SERVICE BULLETIN

FUJI HEAVY INDUSTRIES LTD.

NO : FAS-012A

1. SUBJECT : Inspection of battery.
2. AIRCRAFT AFFECTED: FA-200 Series Aircraft, S/Ns 12 thru 127, equipped with P/N 200-383600-001 battery. | A
3. PRIORITY : Essential.
4. REASON : Battery installation should be inspected for fear that electrolytic fluid leak in case of overfilling or inadequate installation of battery cover.
5. DESCRIPTION : Inspect the battery installation. Work procedure and inspection item are described in No. 13 and No. 14. Have a contact to Fuji H. I., if electrolyte leakage is found.
6. ACCOMPLISHMENT : As soon as reception of this service bulletin and at all 50 hr inspection thereafter.
7. APPROVAL : JCAB Approval (No. 315) January 21, 1969
8. PARTS REQUIRED : Nothing.
9. SPECIAL TOOLS : Nothing.
10. WEIGHT AND BALANCE: No change.
11. REFERENCE : Nothing.
12. MANPOWER : 1 MH.

Fig. 1

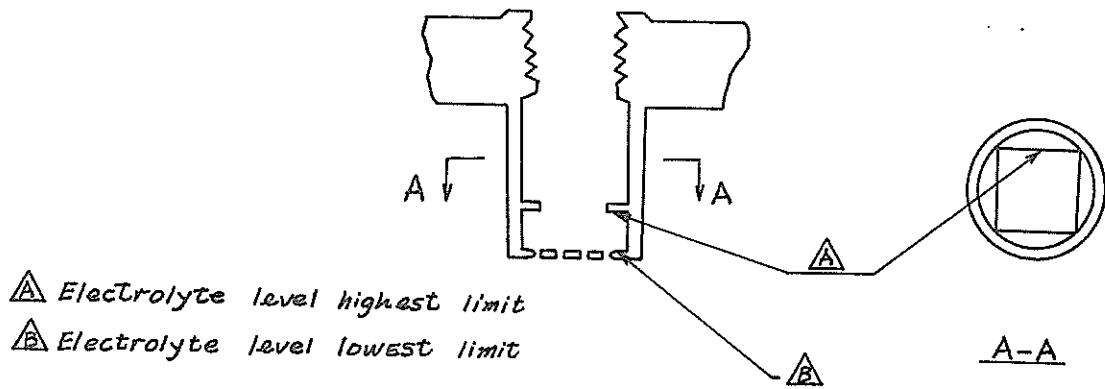
- (1) Check the battery and fuselage structure rear the battery for leakage of electrolyte.
- (2) Charge the battery and check the electrolyte level. Electrolyte level should be within mark A and B (Refer to Fig. 1).
- (3) Tighten battery cell filler caps and check the leakage from the filler caps in upside down condition.
- (4) Check the rim around the battery box for detachment. The rim height should be more than 2 mm (0.08 inch) from the rubber seal. (Fig. 2)
- (5) Check the battery cover for crack.
- (6) Check the vent pipe for the gap between the pipe and cover.
- (7) Install the battery and adjust the clamp screw as there is no gap between the battery cover and rubber seal.
- (8) Cut the tip of outboard side vent tube under fuselage as illustrated in Fig. 3.
